September 16, 2019
BOARD OF COUNTY COMMISSIONERS
ORANGE COUNTY, FLORIDA
Y20-703-RC / ADDENDUM NO. 3
CONSTRUCTION OF ORANGE COUNTY FIRE STATION #87

This addendum is hereby incorporated into the bid documents of the project referenced above. The following items are clarifications, corrections, additions, deletions and/or revisions to, and shall take precedence over, the original documents. Underlining indicates additions, deletions are indicated by ~~strikethrough~~.

• sheet title
**WALL
 SECTIONS**

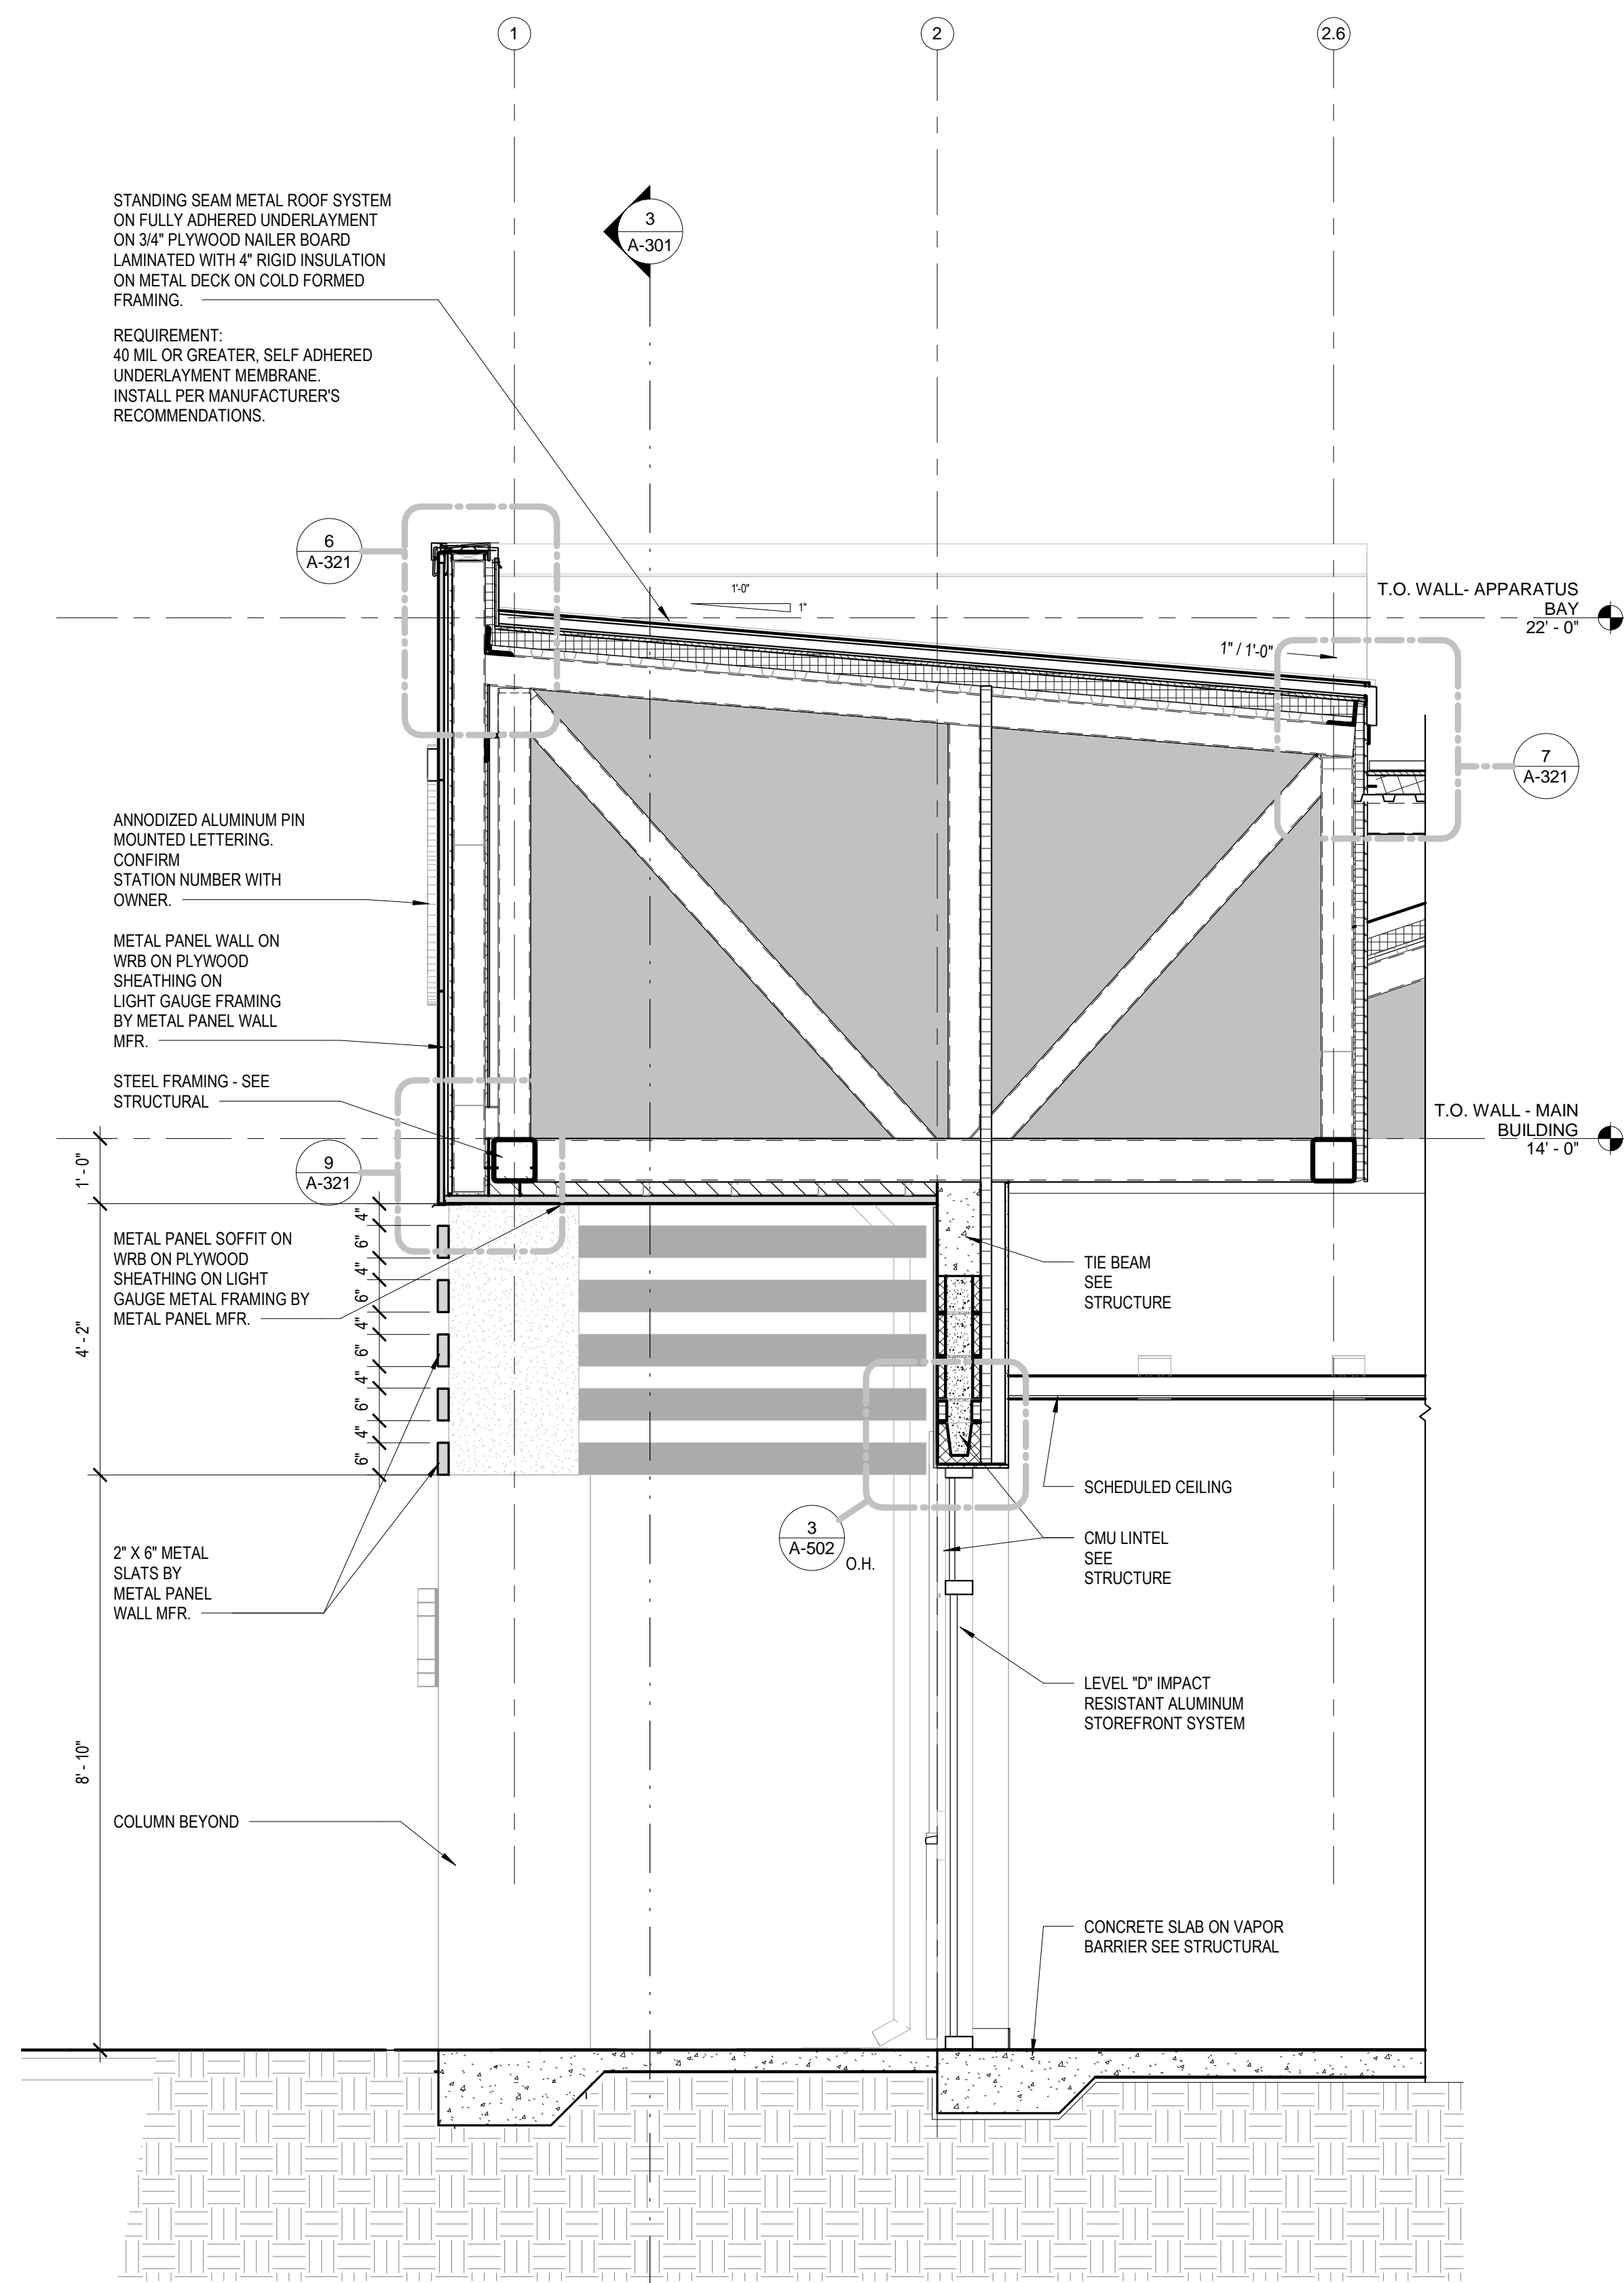
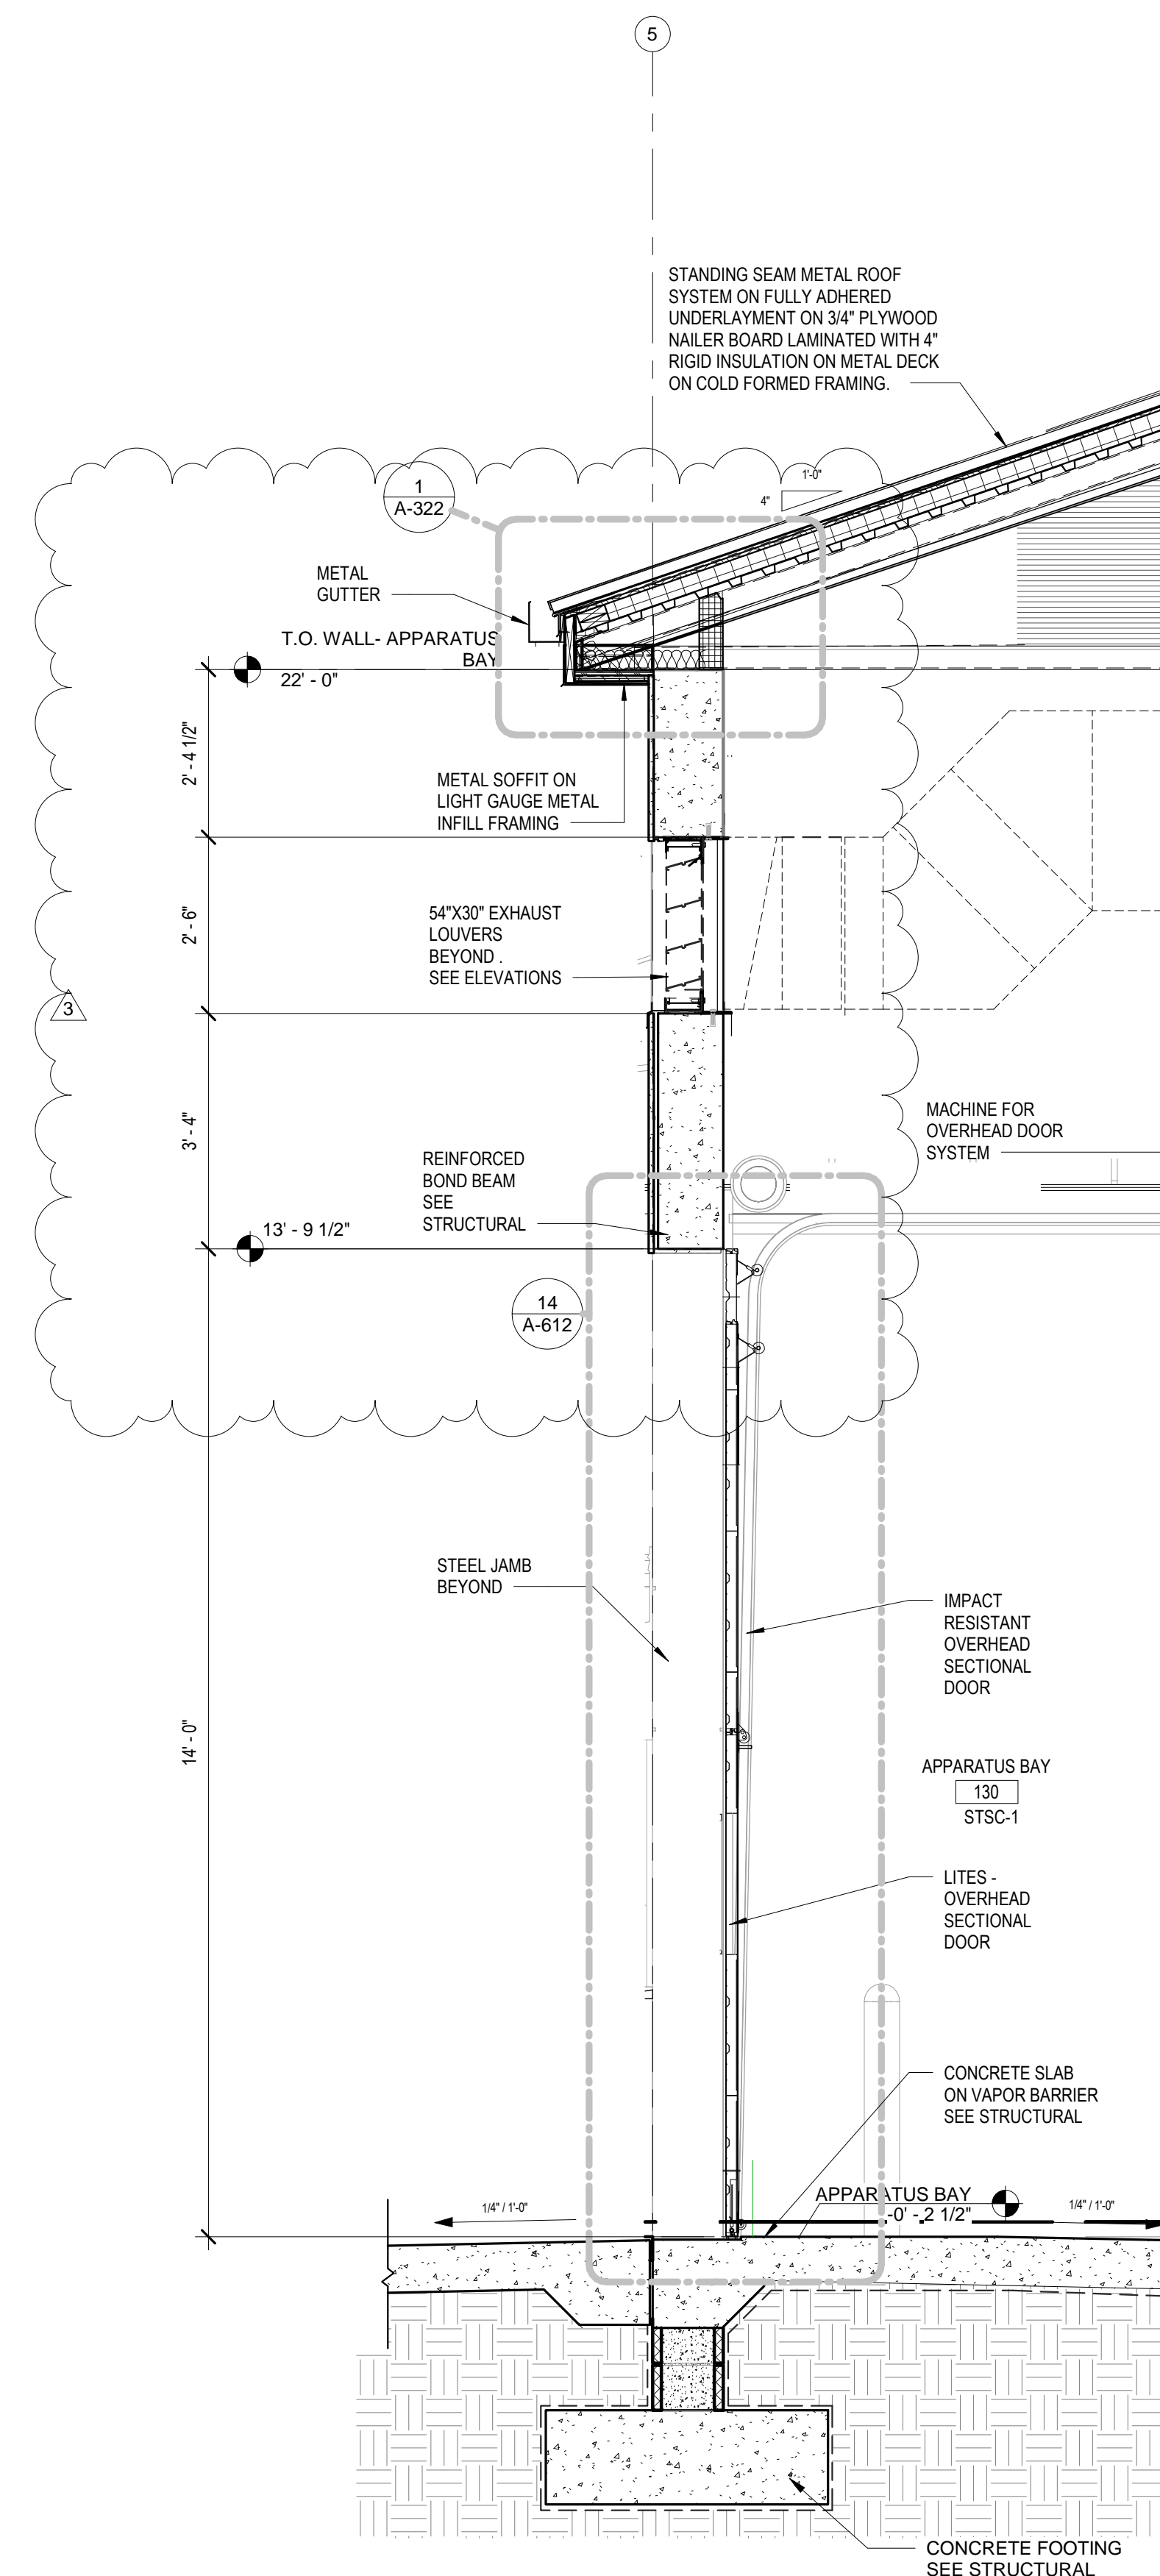
14. **Question:** The OH door specs are almost unusable as there are so many contradictions in material operation and not to mention even the basis of design manufacturer can't meet the level D impact resistance.

Answer: Spec section 083613-Sectional Doors revised and re-issued. Sheets A-202, A-312 & A-501 revised and re-issued to accommodate sectional door operator size.

1 LIGHTING PLAN
 E-201 1/8" = 1'-0"

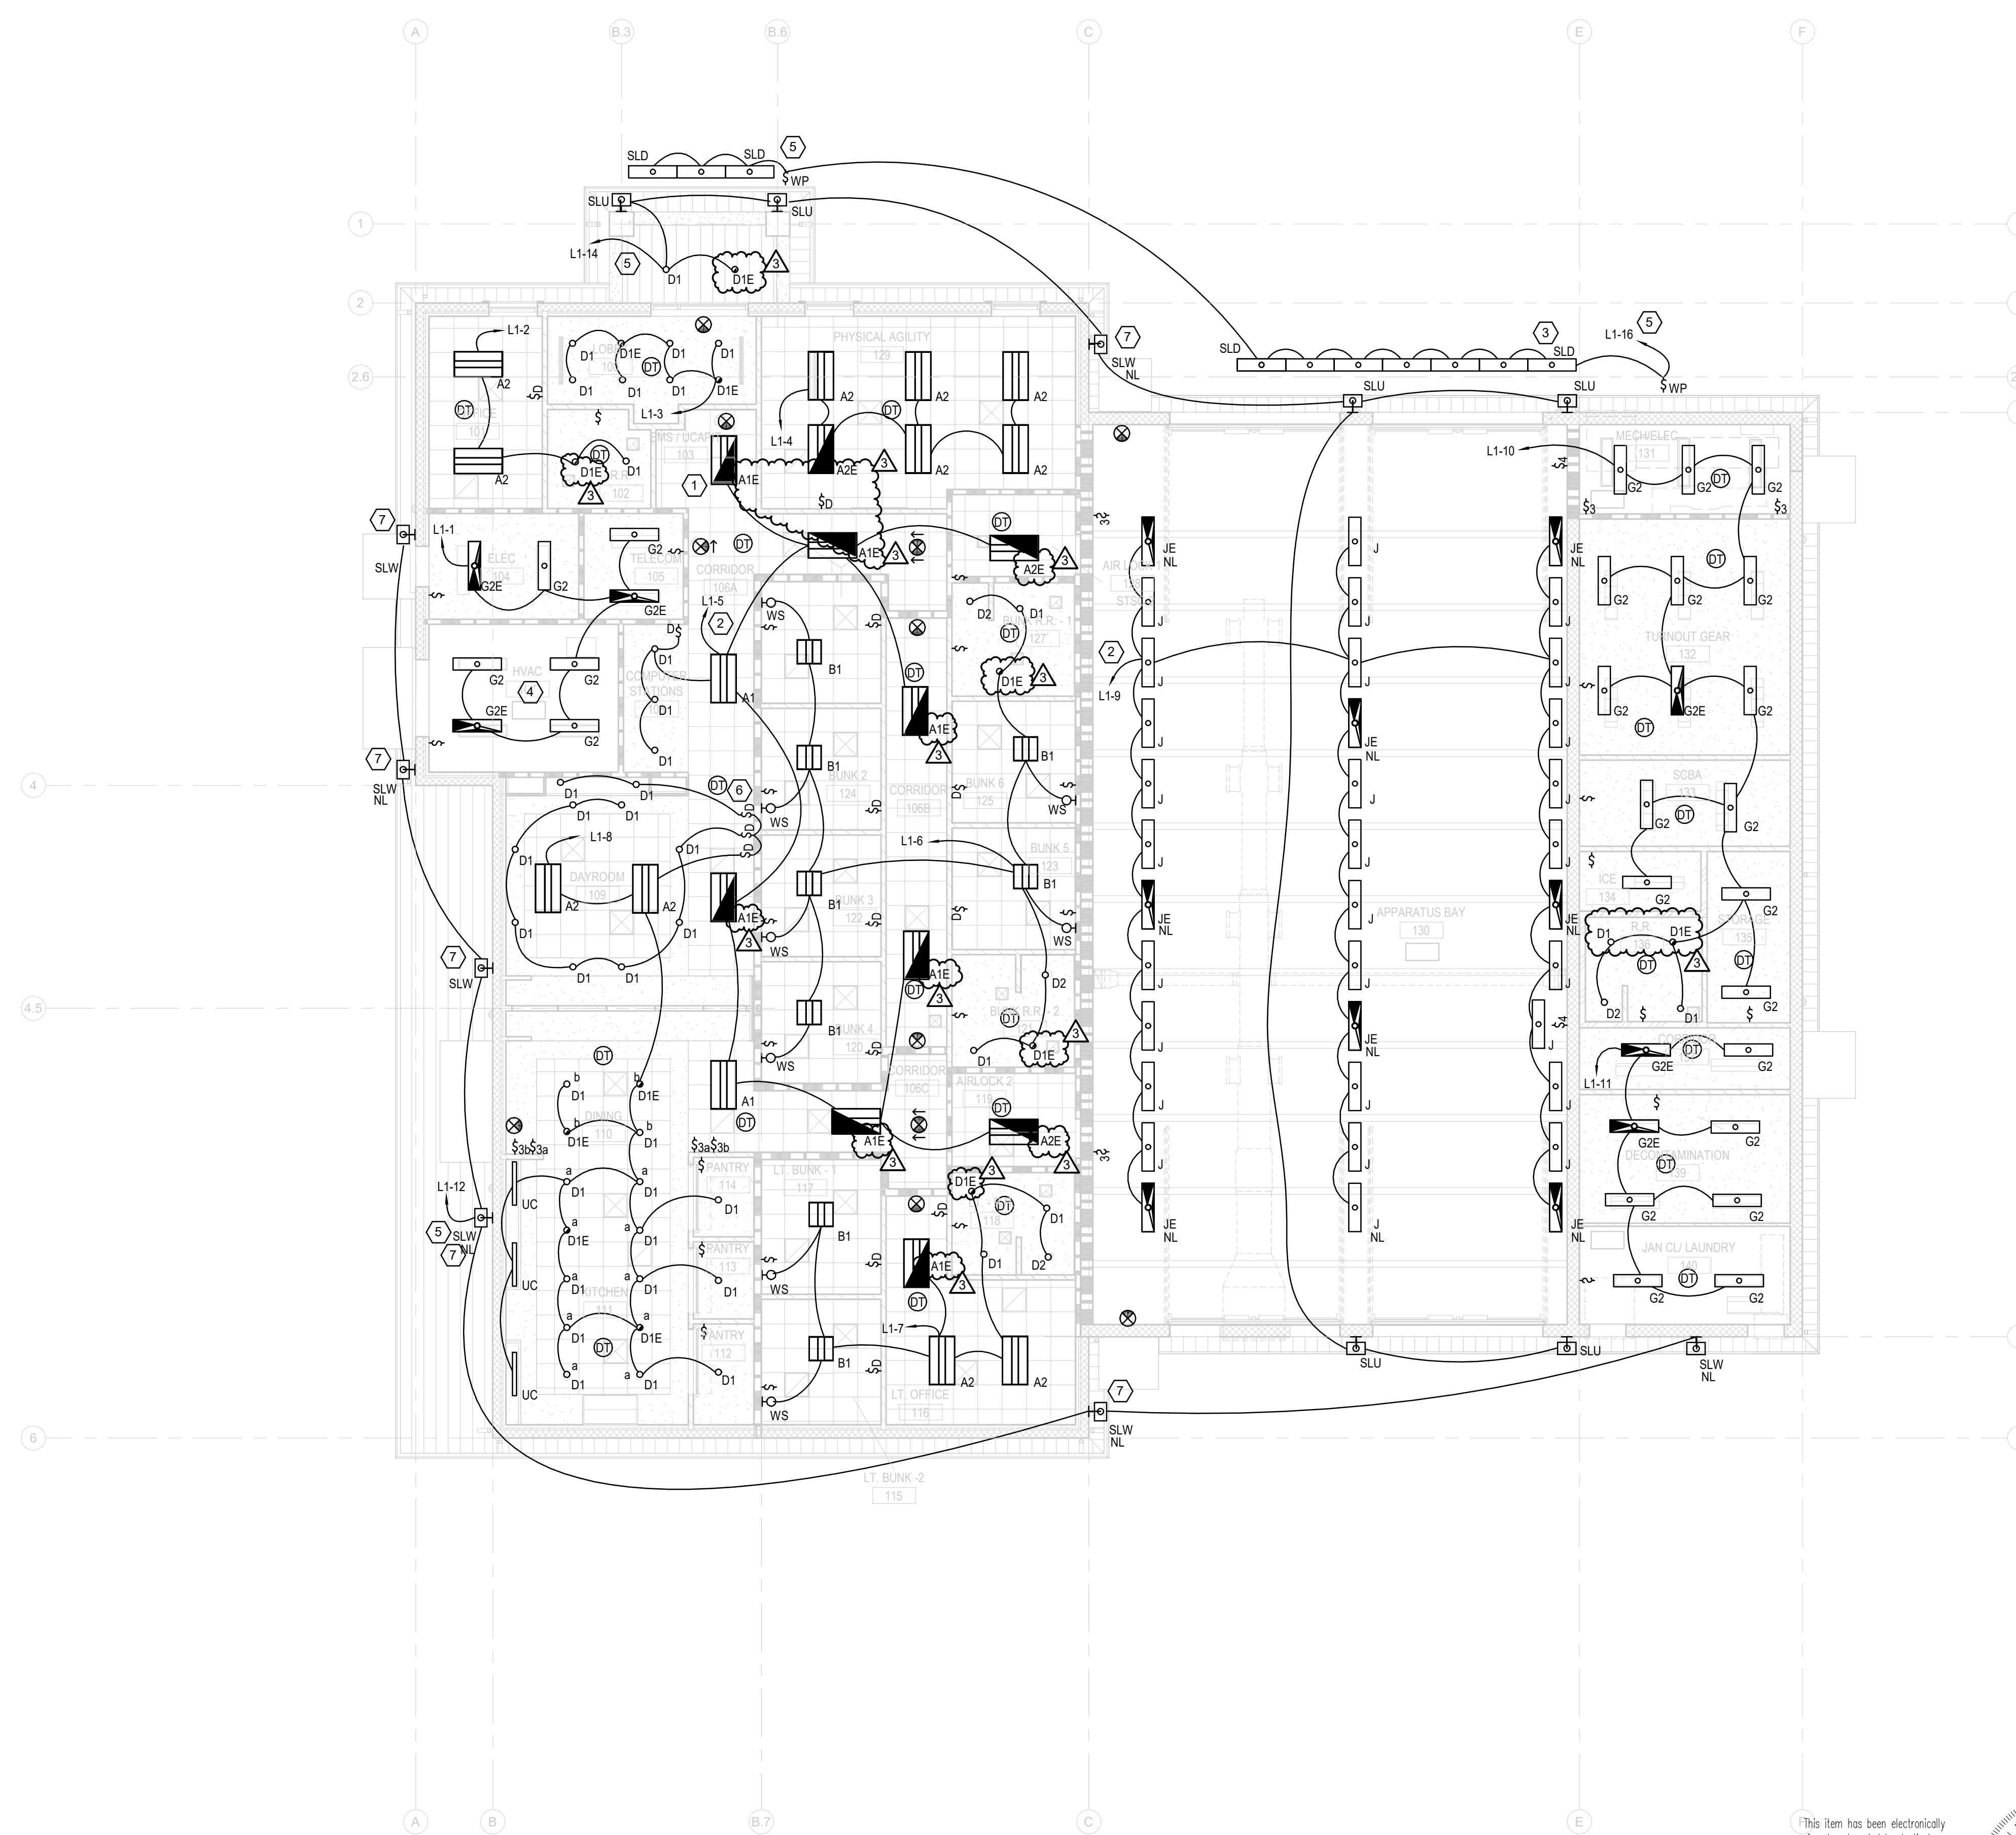
7. **Question:** Fixture types A1, A2, D1E and G2E on sheet E-201 these fixtures appear to be emergency lighting fixtures with proposed battery back-up. The fixture schedule does not indicate these fixture types with being battery backup. Please advise if these fixtures are to be ordered with an EM back-up ballast.

Answer: Emergency battery units are to be provided with fixtures.
